Item 3
**6 Meriton Street, Gladesville - LDA2021/0172
 Demolition, new 21 room boarding house.**
Report prepared by: Senior Planner

**City of Ryde
 Local Planning Panel Report**

DA Number	LDA2021/0172
Site Address & Ward	6 Meriton Street, Gladesville East Ward
Zoning	R4 High Density Residential
Proposal	Demolition of existing structures and construction of a boarding house containing 21 rooms and a manager's room with basement car parking
Property Owner	Meriton Street Holdings P/L
Applicant	Joseph Panetta
Report Author	Greg Samardzic – Senior Town Planner
Lodgement Date	24 May 2021
No. of Submission	Twenty (20) submissions in objection (1st notification period) Five (5) submissions in objection (2nd notification period)
Cost of Works	\$2,378,828.00
Reason for Referral to Local Planning Panel	Contentious Development 2(b) in any other case – is the subject of 10 or more unique submissions by way of objection.

Figure 10 – Proposed site plan

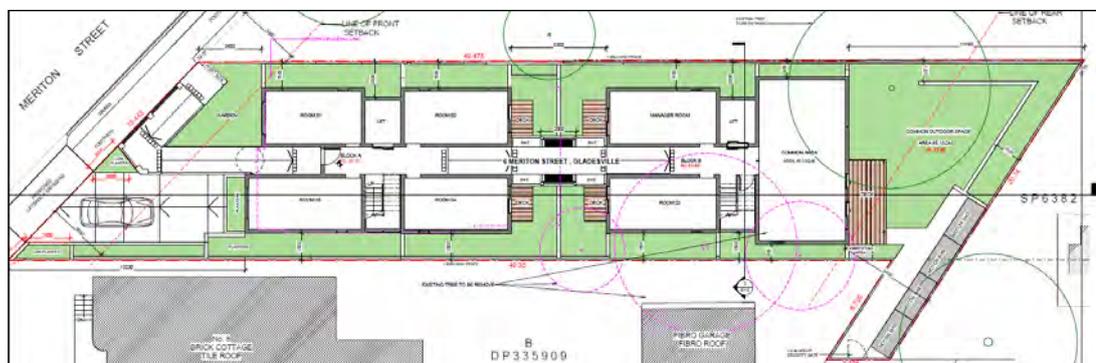
The buildings are proposed to be connected by way of a central walk path comprising a pergola feature. The front setback area contains a vehicle access driveway and a V-shaped pedestrian ramp providing disabled access from street level to the ground floor level. The site plan for the proposal is provided at **Figure 10** below:

Figure 11 – Proposed basement level plan

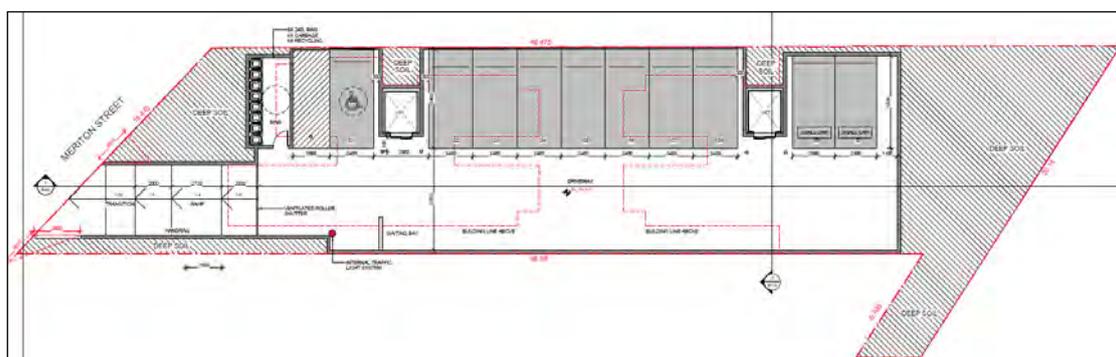
Basement (Figure 11): The basement level is proposed to be constructed at RL30.5 and is proposed to contain 10 car parking spaces (comprising one accessible space), two lift cores and a bin storage area. A one-way access driveway is proposed off Meriton Street.

Figure 15 – Proposed south elevation

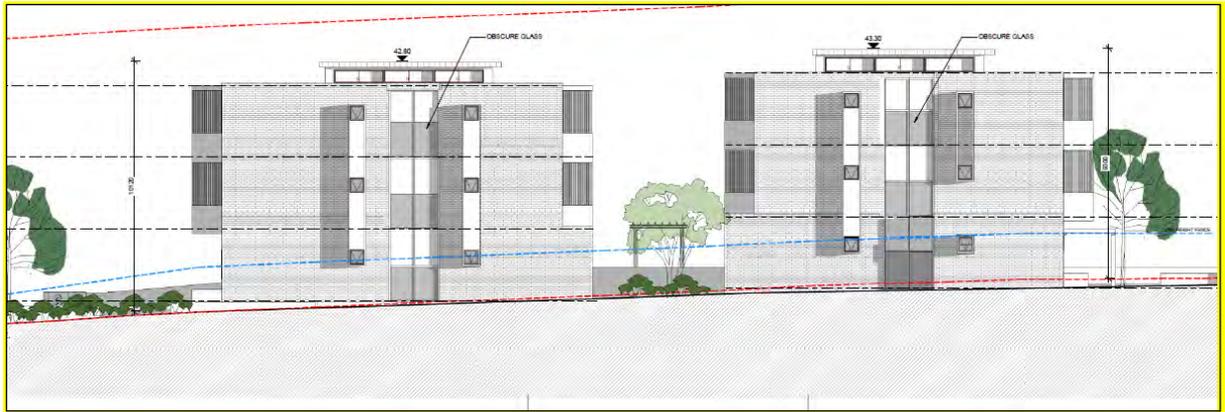
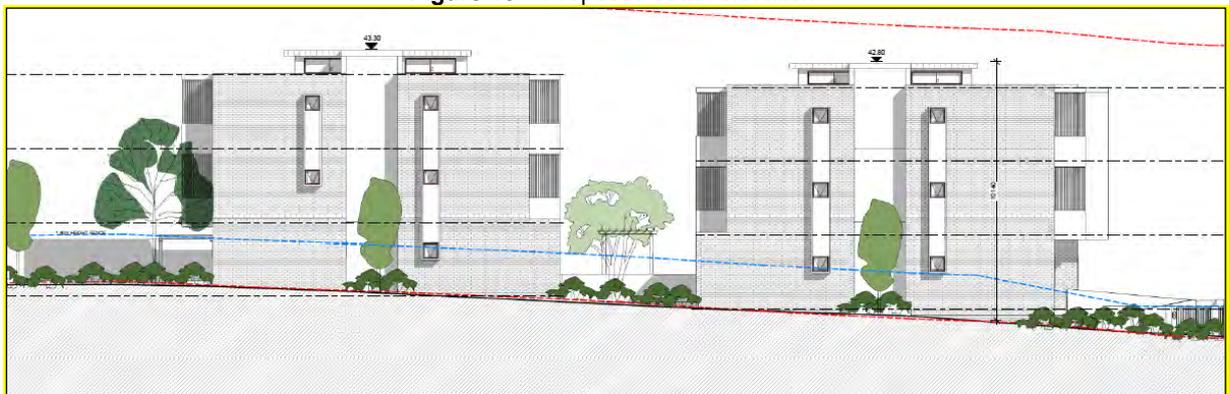
The buildings are proposed to be of a flat roof design and finished in face bricks with rendered feature elements (**Figures 15 & 16**).
